PROJECT NAME: MARION OAKS UNIT 9 TOWNHOMES

APPLICATION: MAJOR SITE PLAN #32259

REVIEW ITEM: Major Site Plan

UTILITY CONNECTION DETAIL

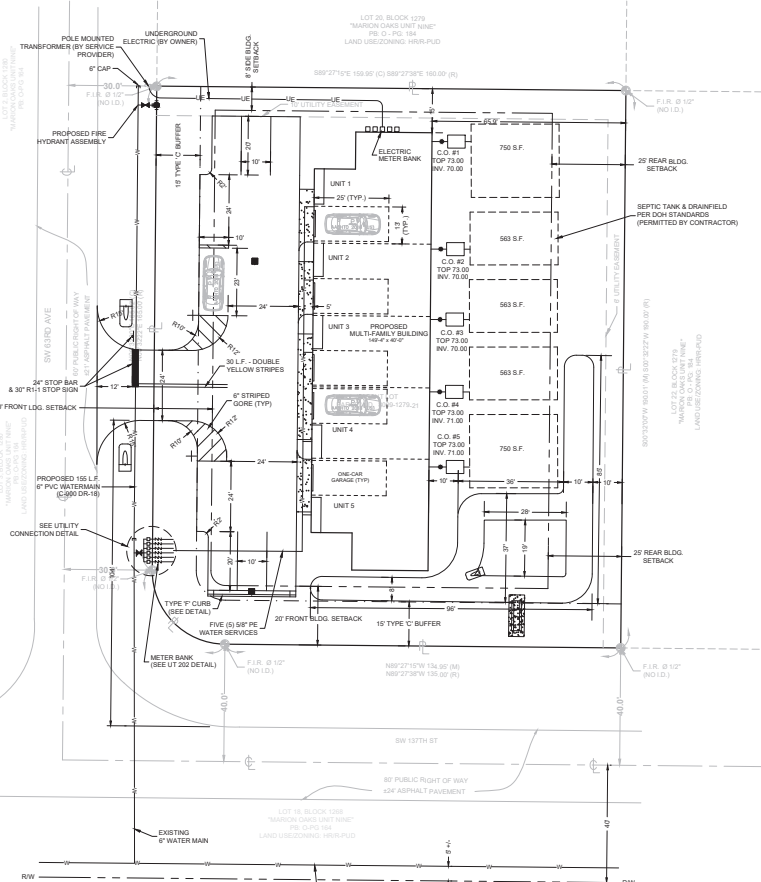
- 36 DEPARTMENT: UTIL - MARION COUNTY UTILITIES
REVIEW ITEM: 6.14.2.A - Water Connection Requirements
STATUS OF REVIEW: NO
REMARKS: NO - Sheet C003 - differentiate existing water main from proposed/new 155 LF water main extension.
INFO - [Since the water main runs along the full southern property boundary, Code does not require any additional water main construction if developer opts to not build this additional WM]

- 43 DEPARTMENT: UTIL - MARION COUNTY UTILITIES
REVIEW ITEM: 6.15.6.A - Potable Water Metering - individual/banked, size
STATUS OF REVIEW: NO
REMARKS: Per MCU detail UT202 a max of 5 meters allowed on a 2" supply. Revise bank or adjust service size to support a larger bank. Call out revision on Sheet C003

- 44 DEPARTMENT: UTIL - MARION COUNTY UTILITIES
REVIEW ITEM: 6.15.6.B - Irrigation Water Metering - size
STATUS OF REVIEW: NO
REMARKS: Sheet C003 - call out size of irrigation meter in "Utility Connection Detail"
